File PDR-1996-217

Name: The Knolls - SE Corner 27 Road /Cortland Avenue

RESPONSE TO REVIEW COMMENTS

STAFF REVIEW - PLANNING COMMISSION REPORT - NOVEMBER 5, 1996 HEARING

FINAL PLAT OF THE KNOLLS SUBDIVISION, FILING I, LOCATED IN THE SW 1/4 OF THE NE 1/4 OF SECTION I, T.1 S., R.1 W., U.M., MESA COUNTY, COLORADO

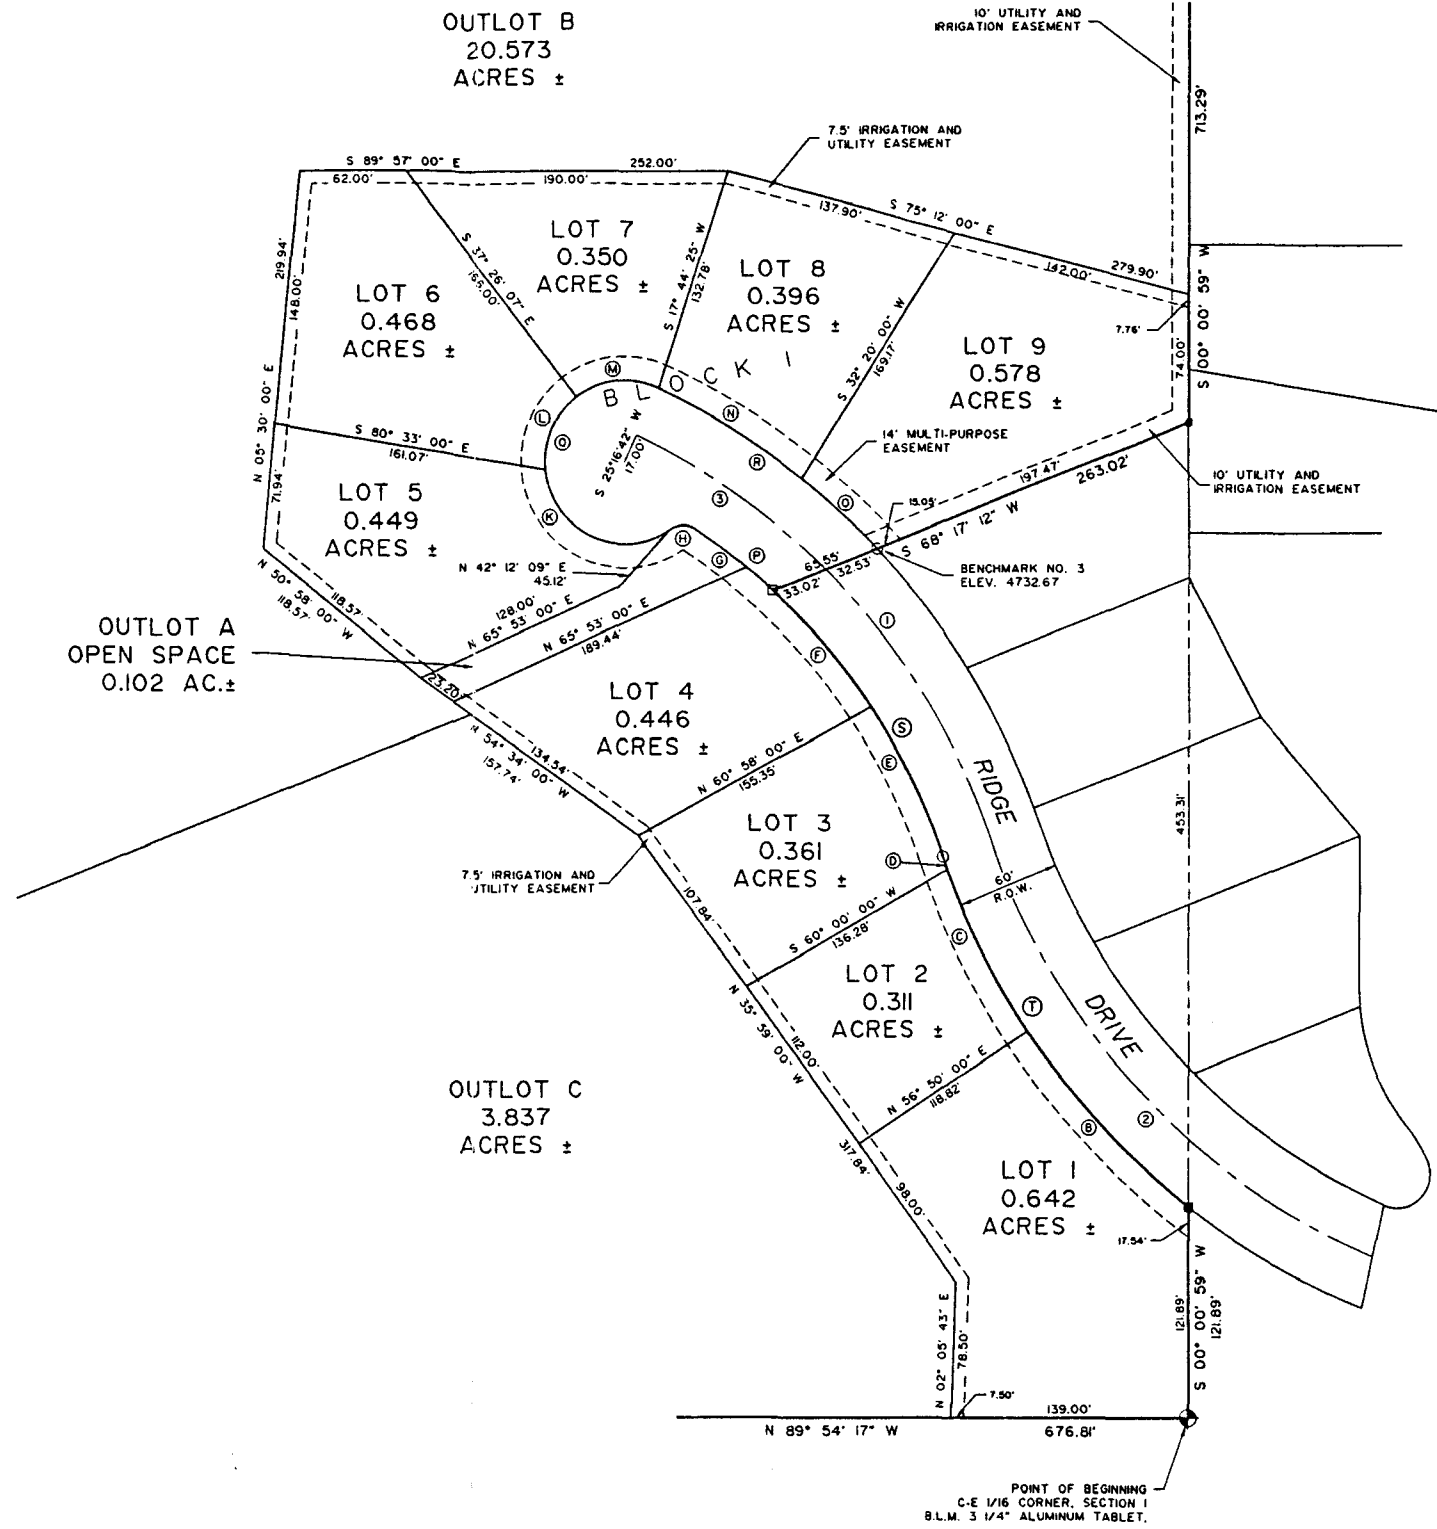
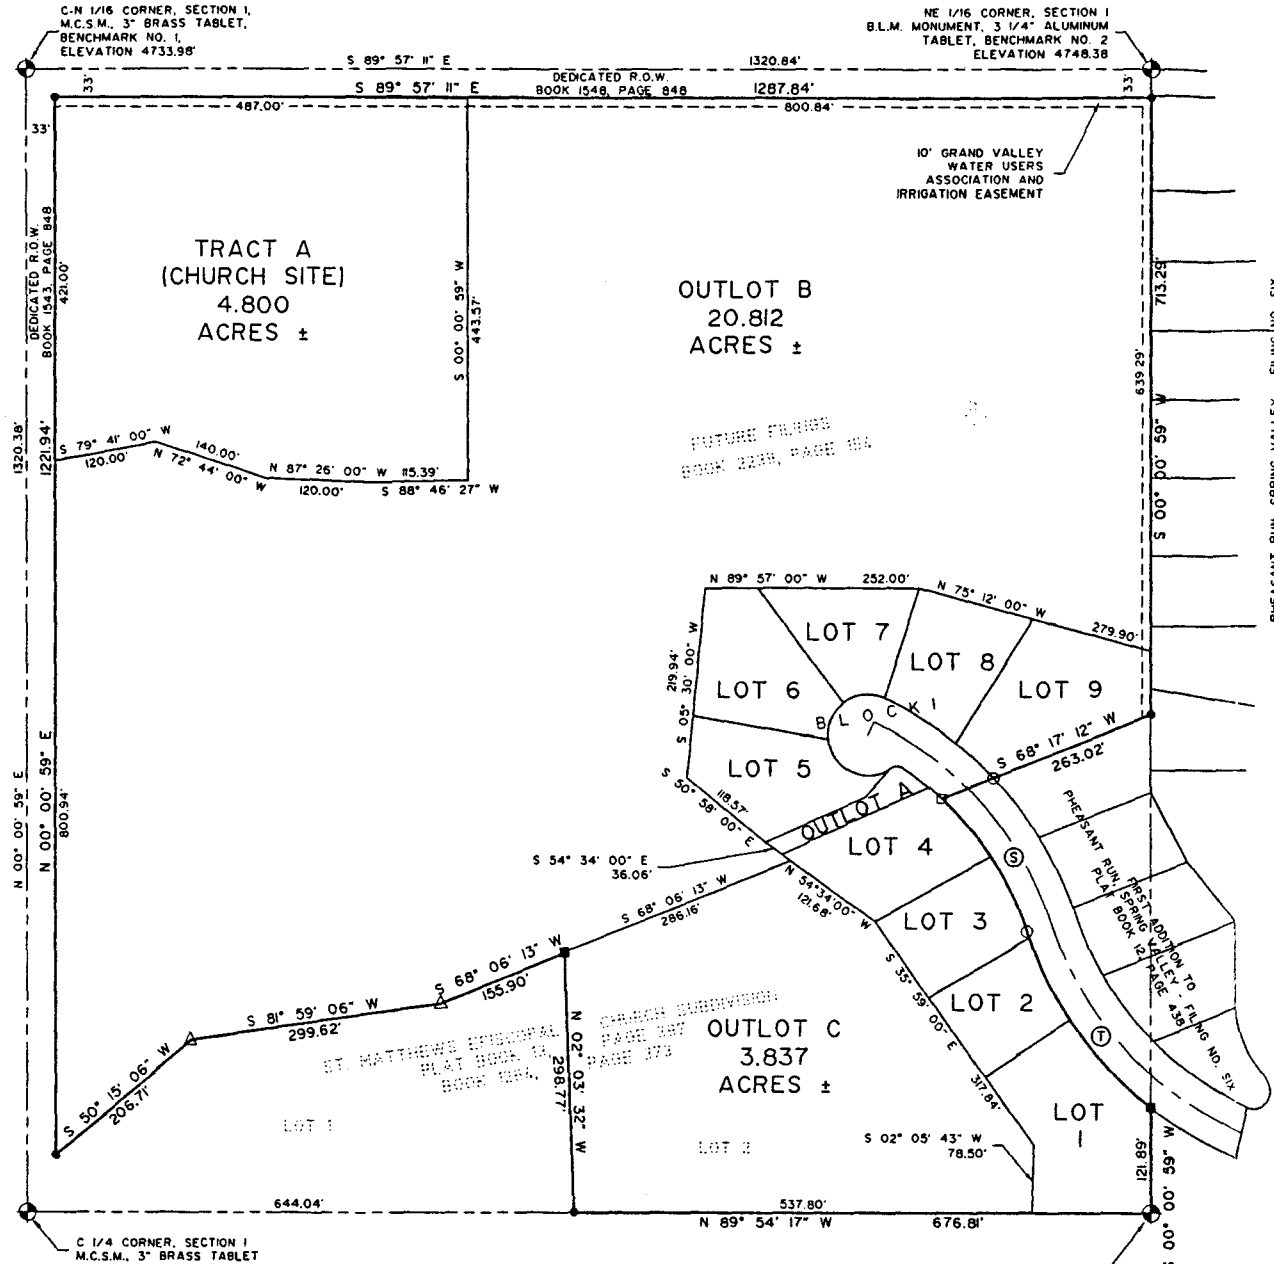
1. To achieve a consistency of platting terms, please redesignate Tract A as a lot. Redesignate Outlot A as a Tract. Outlot B & C shall be designated as lots for future development.
2. What are setbacks for filing #1
3. Cortland Road improvements for the portion adjacent to the church site shall be installed during filing #2
4. Revise plat dedication statement for the pedestrian easement to include the following: "pedestrian easements to the City of Grand Junction as perpetual easement for ingress and egress use by the general public pedestrian."
5. A 10' wide concrete pedestrian path shall be required in Tract A (outlot A). The path shall be shown on improvement plans with an appropriate ramp onto Ridge Drive. Show where drainage will go in relation to the pedestrian path.

1. Outlot B should be labeled Lot 1, Block 2 and Outlot C should be labeled Lot 1, Block 3.
2. Tract "A" should be addressed in the dedication.
3. Remove verbage referring to drainage and detention / retention easements from the dedication.
4. Building set-back lines?
5. Outer monumentation needs to be set or reset in concrete, plus the outer monuments for each block.

1. Redesignation of the tract and outlots has been done.
2. Setbacks for Filing #1 are 25' Front, 10' Side and 25' Rear. These setbacks have been added to the Final Plat.
3. Comment noted, no response necessary.
4. Verbage in plat dedication has been modified as requested.

1. Refer to Response #1 under CITY COMMUNITY DEVELOPMENT, FINAL PLAT.
2. Refer to Response #4 under CITY COMMUNITY DEVELOPMENT, FINAL PLAT.
3. Verbage referring to drainage and detention/retention easements has been removed from the dedication as requested.
4. Refer to Response #2 under CITY COMMUNITY DEVELOPMENT, FINAL PLAT.
5. Monumentation shall be set in concrete as stated.
